#### PLANNING COMMISSION MEETING AGENDA REGULAR MEETING

- SPECIAL USE APPROVAL AND PRELIMINARY SITE PLAN REVIEW (File Number SU JPLN2022-0004) Proposed 2690 Crooks Road Apartments, East side of Crooks, South of Big Beaver (2690 Crooks), Section 28, Currently Zoned BB (Big Beaver) District.
- SPECIAL USE APPROVAL AND PRELIMINARY SITE PLAN REVIEW (File Number SU JPLN2022-0004) Proposed 911 & 999 W. Big Beaver Mixed Use Development, Southeast corner of Big Beaver and Crooks (PIN 88-20-28-101-032, -034 and -047), Section 28, Currently Zoned BB (Big Beaver) District.

SUBJECT: SPECIAL USE APPROVAL AND PRELIMINARY SITE PLAN REVIEW (File

# Preliminary Site Plan and Special Use Review For City of Troy, Michigan

**OVERALL SITE PLAN**

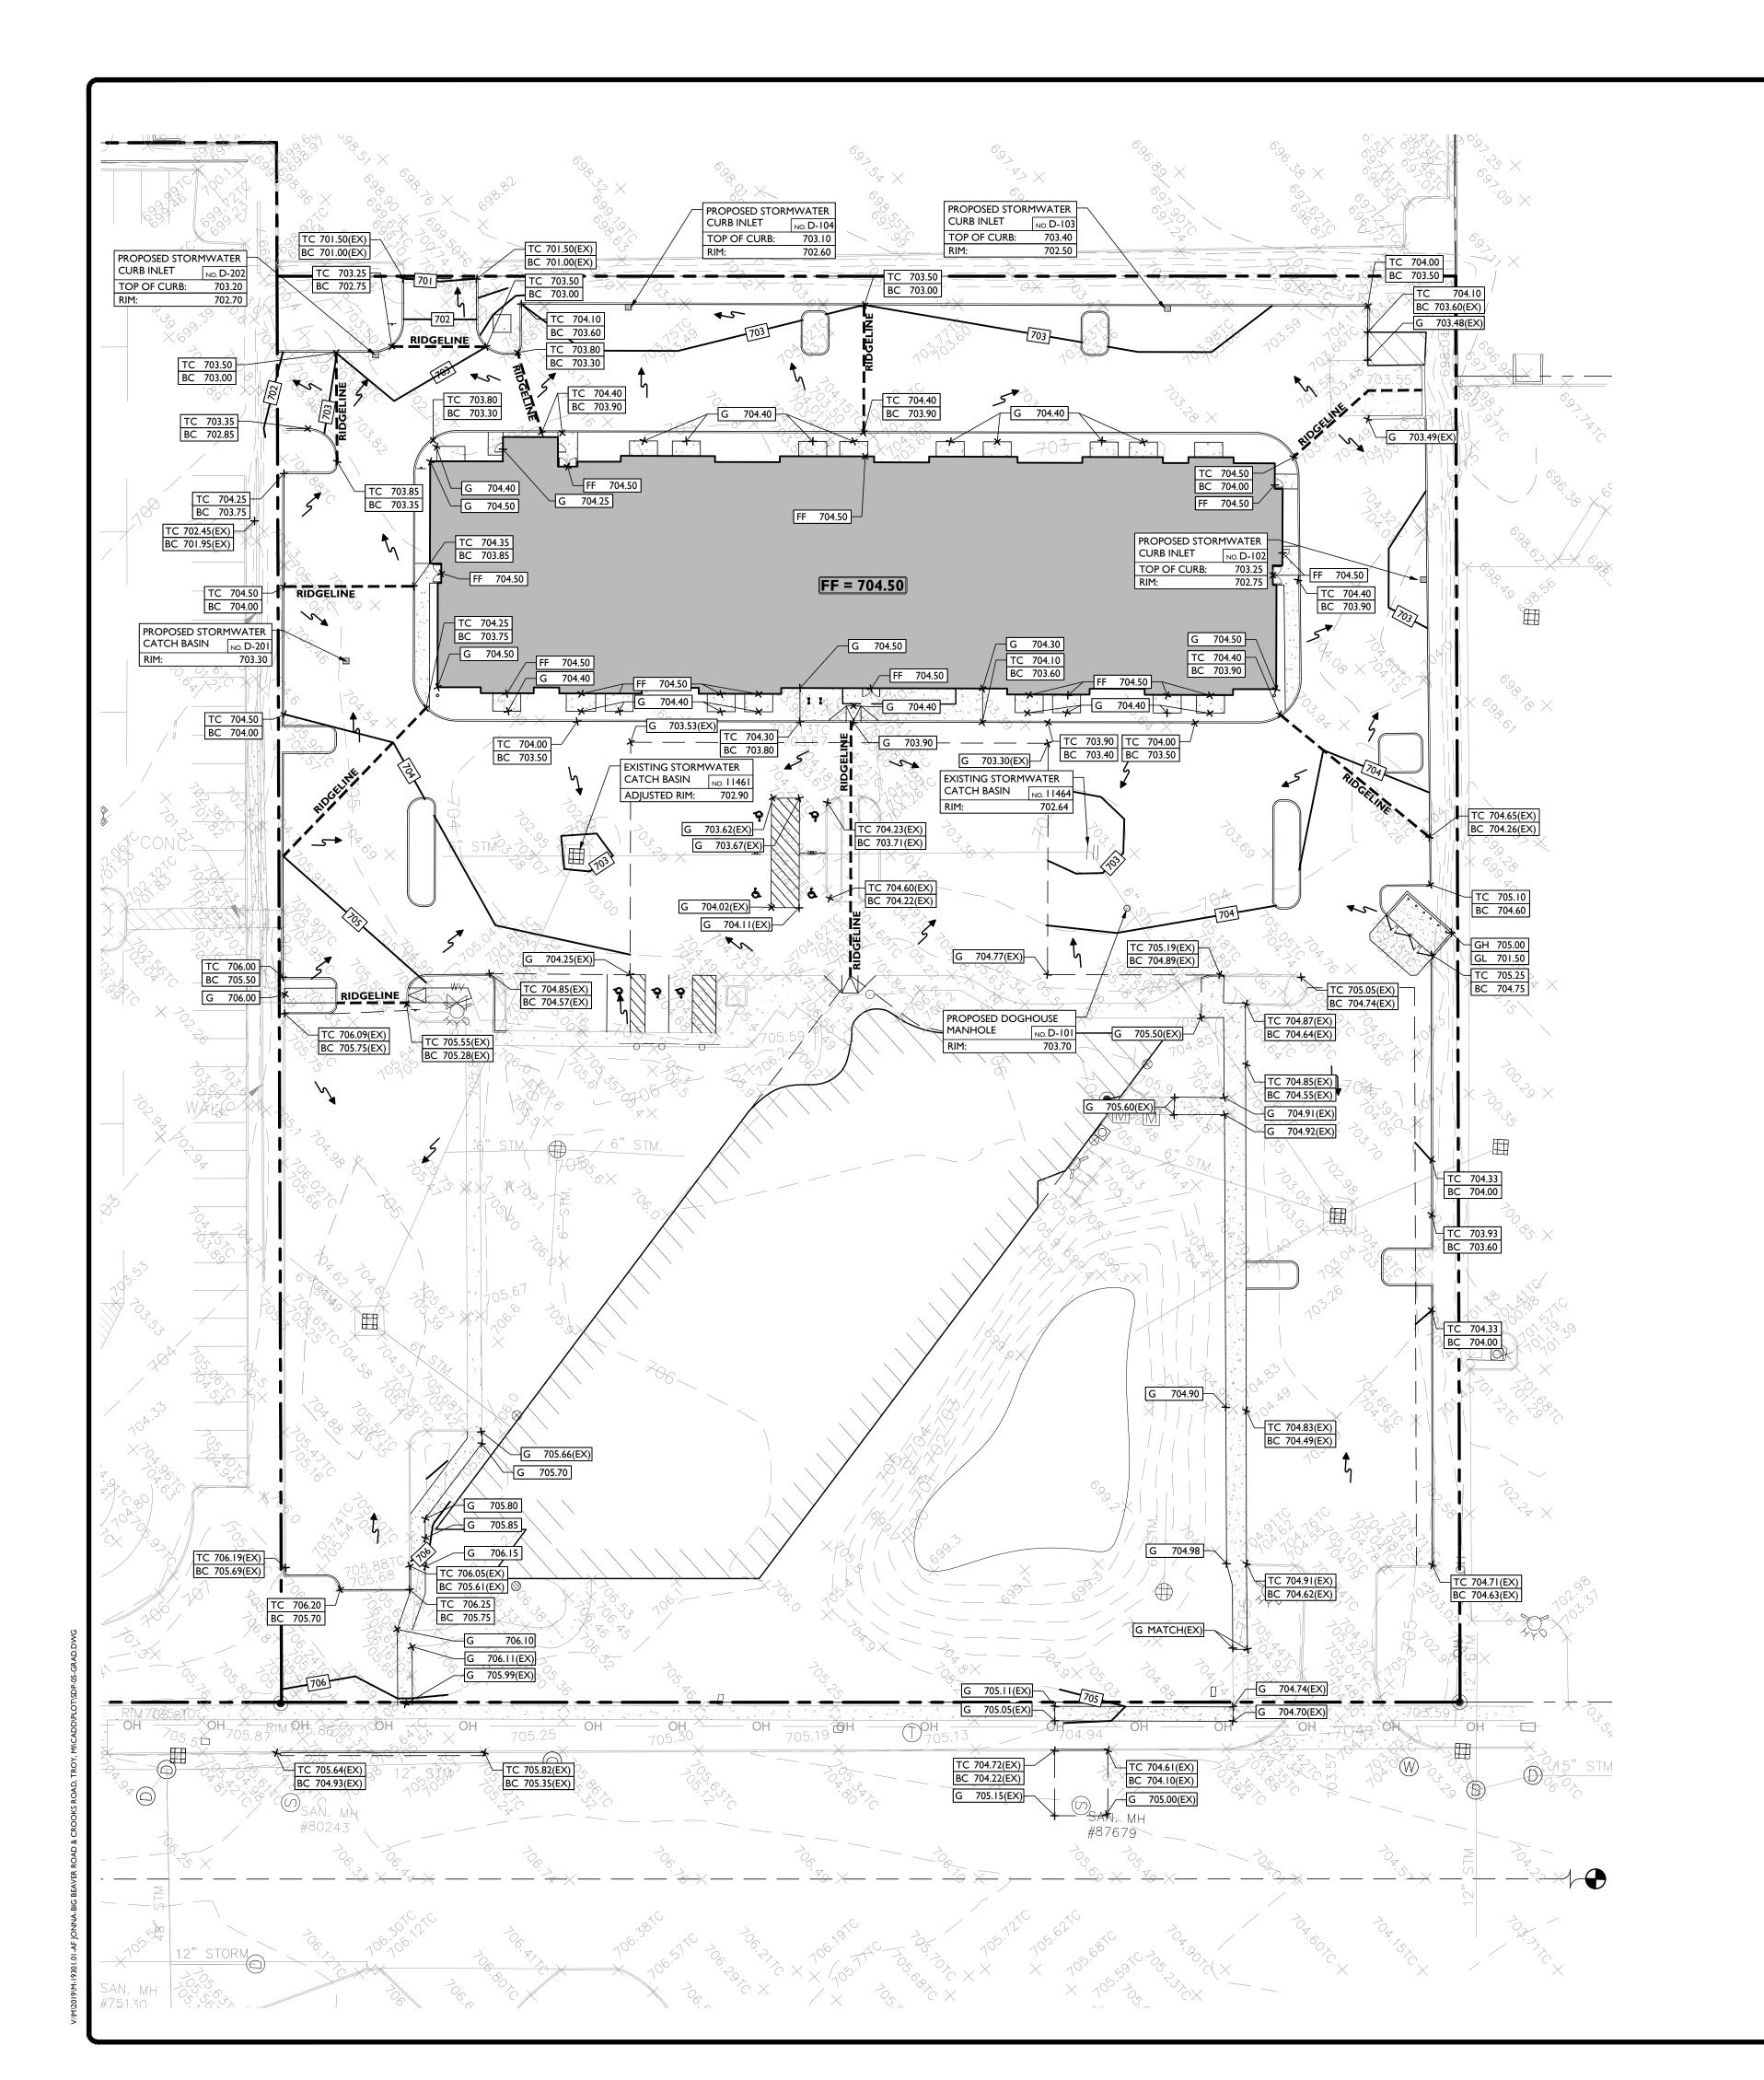
The proposed sidewalk connection to the north is noted on the plans: "LIMIT OF PROPOSED CONCRETE SIDEWALK. REMAINDER OF ADA CROSS-ACCESS PATHWAY TO BE COORDINATED WITH ADJACENT SITE CONSTRUCTION" This implies that the two sites will be constructed concurrently. However, what if work on this site precedes the site to the north? Since this development proposes shared parking on the adjacent site, there must be suitable pedestrian connections constructed as part of this development in the event the two sites are not constructed concurrently.

The proposed sidewalk connection to the north is noted on the plans: "LIMIT OF PROPOSED CONCRETE SIDEWALK. REMAINDER OF ADA CROSS-ACCESS PATHWAY TO BE COORDINATED WITH ADJACENT SITE CONSTRUCTION" This implies that the two sites will be constructed concurrently. However, what if work on this site precedes the site to the north? Since this development proposes shared parking on the adjacent site, there must be suitable pedestrian connections constructed as part of this development in the event the two sites are not constructed concurrently.

**C-9**

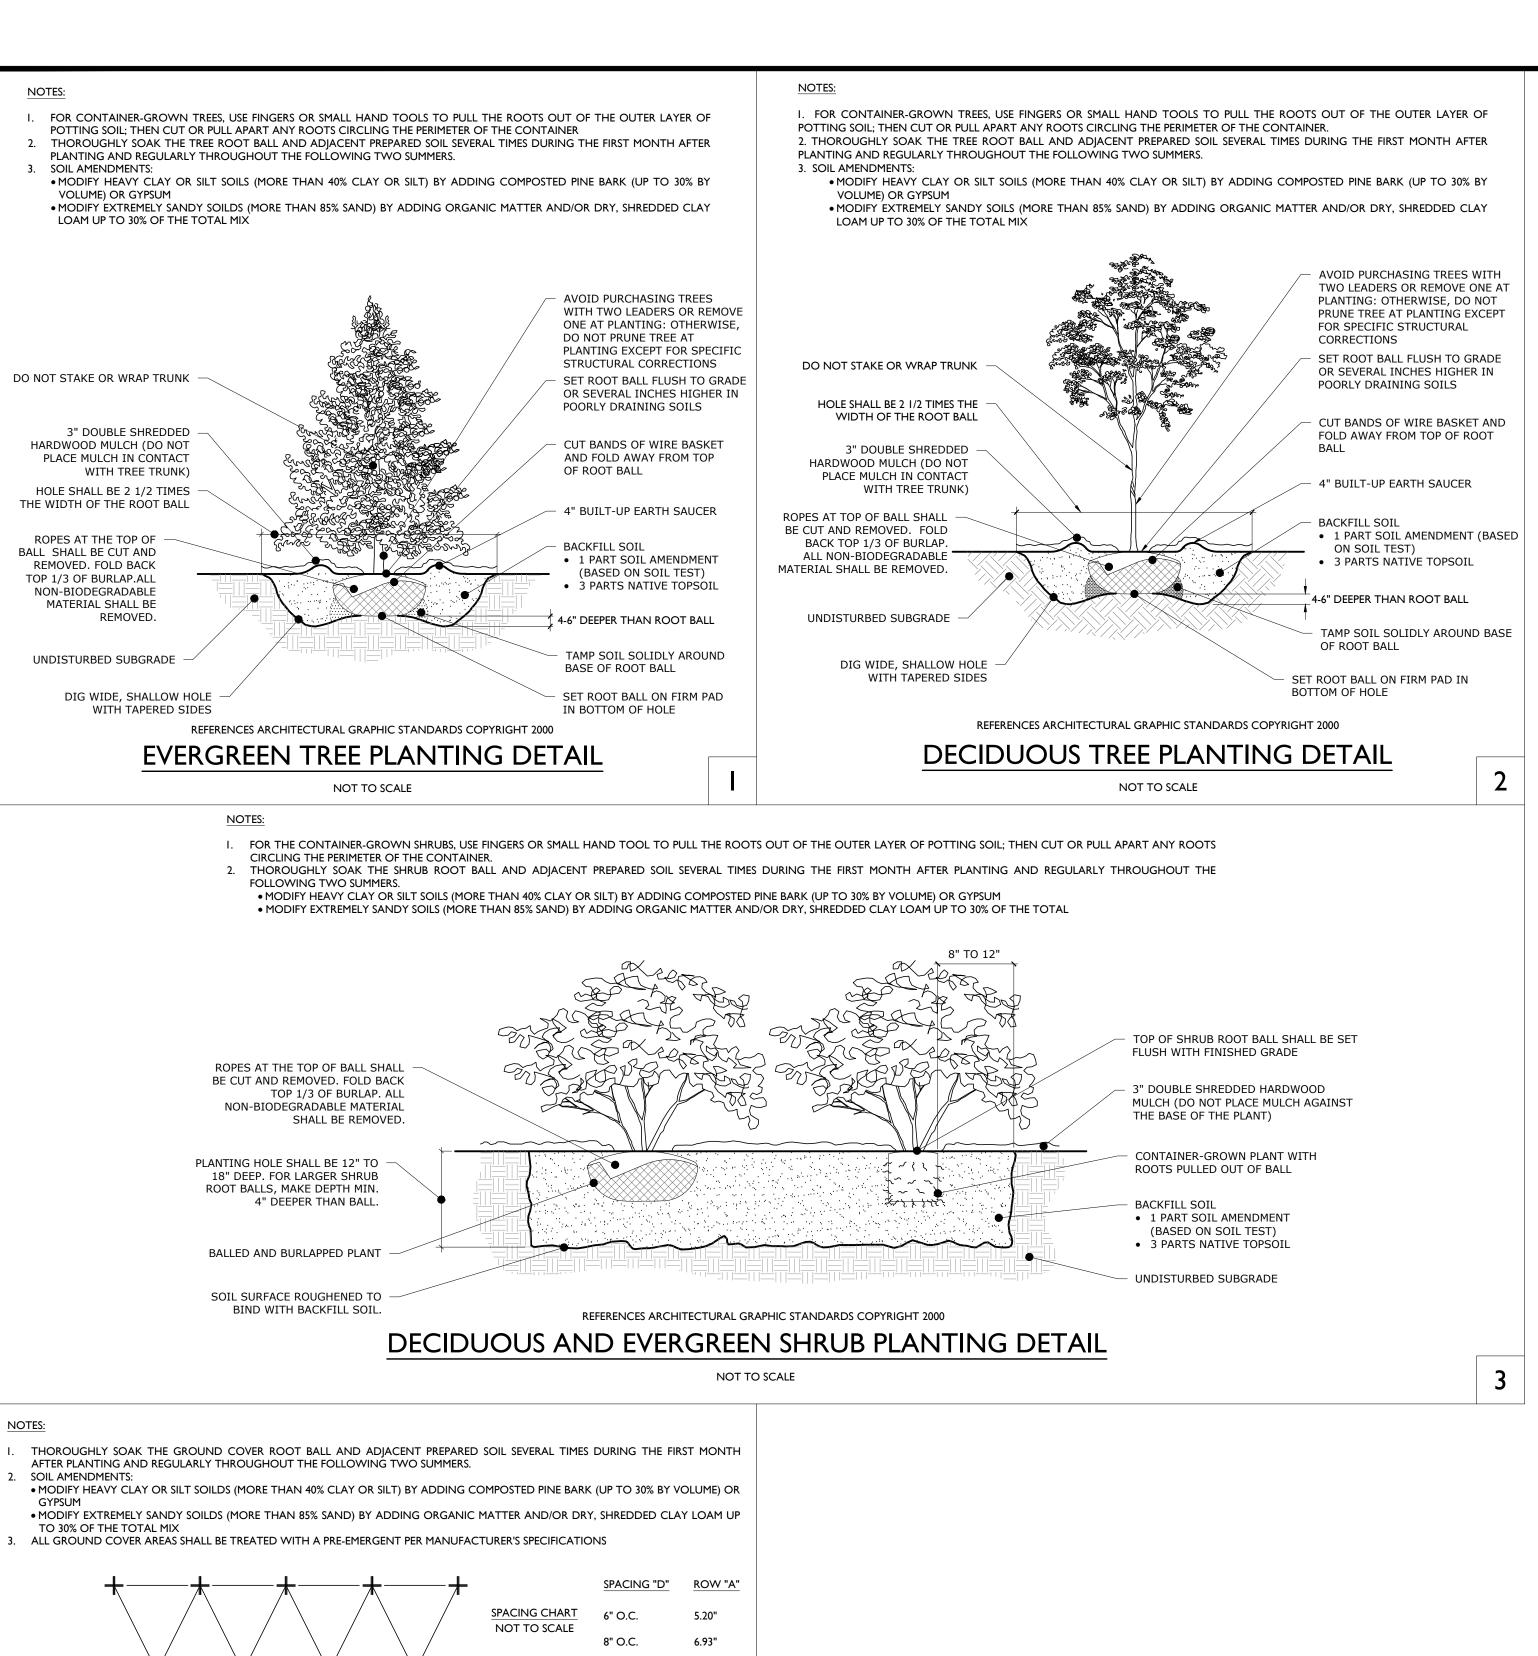
A landscaping plan has been provided on Sheet L101. The following table discusses the development's compliance with the landscape requirements set forth in Section 13.02.

The applicant is required to provide 28 parking lot trees. Sixteen (16) of the required twenty-eight (28) trees are in parking lot and fifteen (15) are along perimeter of parking lot. Planning Commission may allow alternative location of parking lot trees.

The applicant has noted that existing trash enclosure will be surrounded by chain-link fence with slats. The applicant should replace chain-link fence with wall. For the new trash enclosure, the applicant has not provided any trash enclosure screening details other than noting that they will screen with landscaping.

**Items to be Addressed**: 1). Planning Commission to discuss parking lot tree location; and 2). Provide trash enclosure screening details that comply with section 13.02.
